**From:** WILLIFORD Dennis (AREVA) [Dennis.Williford@areva.com]  
**Sent:** Monday, April 29, 2013 5:27 PM  
**To:** Snyder, Amy  
**Cc:** Miernicki, Michael; ANDERSON Katherine (EXTERNAL AREVA); DELANO Karen (AREVA); LEIGHLITER John (AREVA); ROMINE Judy (AREVA); RYAN Tom (AREVA)  
**Subject:** Response to U.S. EPR Design Certification Application RAI No. 547 (6499, 6359), FSAR Ch. 3 - NEW PHASE 4 RAI, Supplement 6 - Part 4 of 4  
**Attachments:** RAI 547 Supplement 6 Response US EPR DC Part\_4of4.pdf

Amy,  
Attached is Part 4 of 4 of the response to RAI No. 547, Question 03.07.02-78.

The following table indicates the respective pages in the response document, "RAI 547 Supplement 6 Response US EPR DC.pdf," that contain AREVA NP's response to the subject question. Appended to this file are affected pages of the U.S. EPR Final Safety Analysis Report in redline-strikeout format which support the response to RAI 547, Question 03.07.02-78.

Figure 3.8-112—Elastic Displacement for Soil Case 1n5a

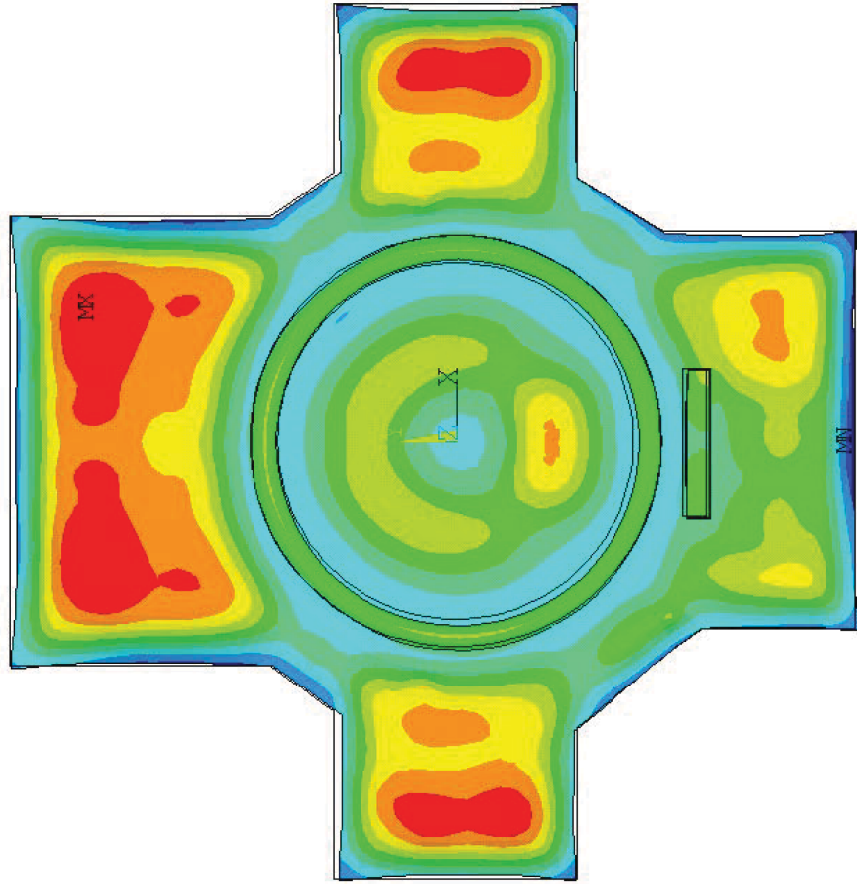
1 STEP=9  
SUB =1  
TIME=.700E-04  
UZ  
TOP  
RSYS=0  
DMX =.038767  
SEPC=27.4383  
SMN =-.038563  
SMX =-.959E-03

Z-Disp Rel to Support (in) , 1n5aeh, Cracked, 7.E-05 s  
-.038563    -.034385    -.030207    -.026029    -.02185    -.017672    -.013494    -.009316    -.005138    -.959E-03  
REV 005  
N008 T2
